# **Architectural and Curation-Needs Assessment for GSA Collections and Proposed Curation Facility, Foley Square Project**

**Architectural-Archaeological Report Series No. 5**

**General Services Administration  
Northeast and Caribbean Region**

**US Army Corps  
of Engineers.**  
St. Louis District

Figure 1- South Street Seaport Museum's proposal for curating the Five Points Collection.

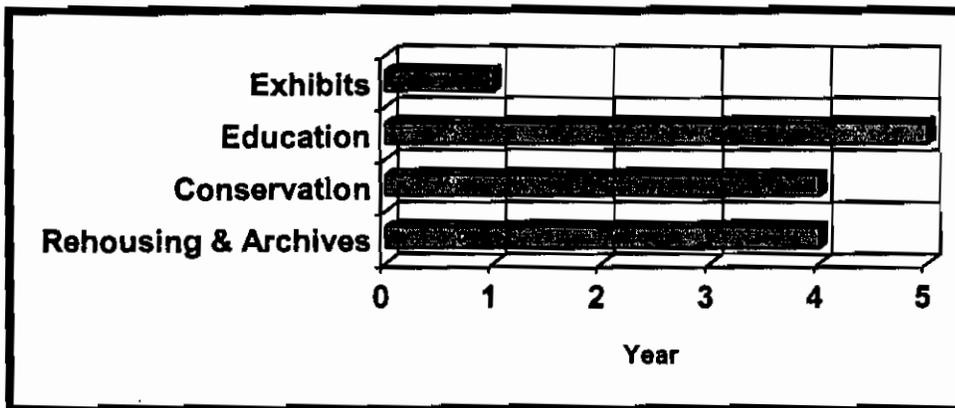
The programmatic and financial information provided by the SSSM in connection with their proposal to provide long-term curatorial services indicates a well-conceived program for the establishment of a well-equipped curatorial facility. The list provided for personnel, equipment, and supplies required would be sufficient to address any conceivable need of the Five Points collection. However, as thorough as it may be, the proposal may not directly address the immediate needs of the collection. Prior to the establishment of a long-term curatorial regime, the collection requires immediate rehabilitation.

Implicit within the proposal provided is a four year program comprised of four persons, the curator of archaeology, a registrar, a conservation technician, and a curatorial assistant, to document, rehabilitate, and conserve the collection, as well as develop an educational program and exhibits (Figure 1). The advantage of this approach is that there is strict intellectual and supervisory control over the processing of the collections. And, it permits GSA to take a "pay-and-forget" approach reducing GSA's need for oversight as well as eliminating some potential GSA administrative costs. The disadvantage to this plan of action is that it does not put resources against tasks in what we believe represents the most efficient and timely fashion in which to complete rehabilitation of the collection. Based upon the existing number of boxes of archaeological collections, SSSM's approach would produce a completion rate of just over 1 box per day. This low rate of completion is achieved because, of the four individuals who would be directly involved in rehousing and conserving the collection, only the curatorial assistant, with occasional assistance from the conservation technician, would be accomplishing the actual task of rehousing the collection, which is the largest single task and the task we believe must receive the lion's share of the resources in a long-term strategy. In addition, the inclusion of an

We would recommend a more directed and phased approach that addresses the immediate needs of the collection, which is to establish archival control of the at-risk associated documents while completing collection management and rehousing of the collections (see Figure 2). The tasks that must be completed in order to prepare the collection for long-term curatorial care are relatively straight-forward and conducive to completion in stages. By managing the collections first, GSA and SSSM will also be more efficient in their development of educational and community-based exhibits. It is necessary to understand your universe before preparing educational programs or exhibits.

As stated previously, archivally preparing the associated documents is the first step that should be completed. The documents are at greatest risk and are needed as data for the collections management program. Additionally, from the prepared documents working copies may be prepared that will allow systematic checking of the artifacts as they are processed. By addressing the archives first, the documents are stabilized and staff will then be able to use the documentary data to note any discrepancies in the excavation records that require clarification from the excavators without disrupting rehousing efforts. In addition, rehousing staff would have a corpus of documentary data to consult regarding the artifacts recovered for each excavation unit as they are working on the rehousing. Missing or misplaced artifacts would then be immediately noted.

Figure 2- MCX-CMAC proposed time frame for the Five Points Collection

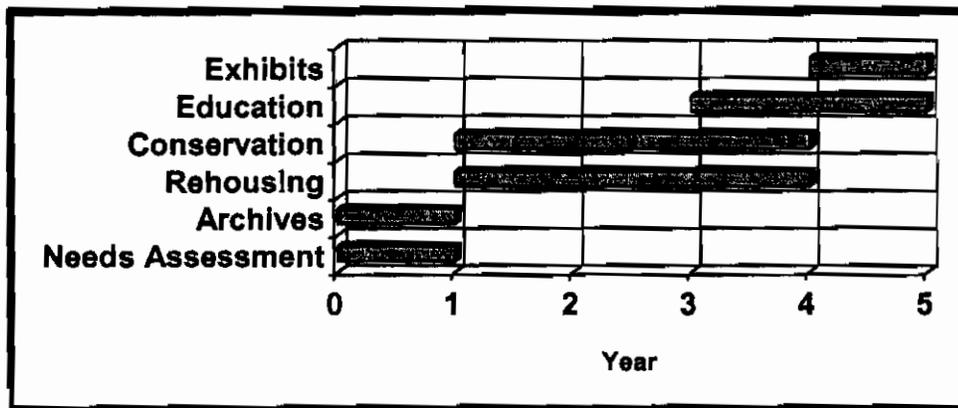
In Part II of our recommendation, we propose museum staff prepare a detailed needs assessment and workplan for the rehousing of the objects. This workplan should address how the museum plans to rehouse the collection and how they propose to manage the collection-down to the data management system to be used. The needs assessment should tie the rehousing efforts to specific needs for supplies and labor expenditures to complete the rehousing in a three year time span. Issues to be addressed include an organizational schema based on provenience and material type, a specific supplies list for rehousing materials, a protocol for conservation including supplies and equipment required, and a protocol for processing the objects. We believe this needs assessment and workplan can be completed in one year's time. The workplan

General conservation of the artifacts, particularly whole vessels, can begin simultaneously with rehousing of the archaeological collection. We believe that conservation and rehousing should proceed in Year 2, after acceptance of the needs assessment and workplan. As previously noted there are specific materials that will require different kinds of attention. This should be spelled out in SSSM's needs assessment. The equipment and supplies specified in the SSSM proposal for the conservation lab may well be required. However, without knowing the specific needs of the collection based on a plan of action, current funding projections appear excessive. We propose the preparation of such a conservation/collections management workplan during the needs assessment that begins with the immediate known requirements of the collection, e. g., rehousing, conservation of leather goods and preparation of housings for fragile objects, etc. During the process of the needs assessment of the collection, the specific conservation requirements for the collection should be more precisely determined and a workplan specifying the appropriate equipment and supplies required could be submitted for GSA's approval.

Finally, the SSSM proposal includes exhibit personnel in the first year budget and an educational programmer from the first year onwards. Until the collection is well into rehabilitation and rehousing, MCX-CMAC believes this is premature. It would seem more optimal to begin educational programming after the rehousing has been mostly completed. Then, the educational programmer and exhibits personnel can develop plans based more firmly on the contents of the collection. In addition, the funds originally programmed for exhibits and education can initially be used to devote more personnel (at lower salaries) to rehousing the collection, thereby speeding the process. We believe this phased plan is a more effective use of government resources. It calls for a detailed needs assessment of the collections which is then tied directly to funds for personnel and materials. It proceeds in steps and allows the museum to develop an understanding of the collection and its assets before embarking upon an educational program. This system allows control of resources and ensures the education program does not become constructed on premises and promises that cannot be met. In short, we have reprioritized the tactics and schedule.
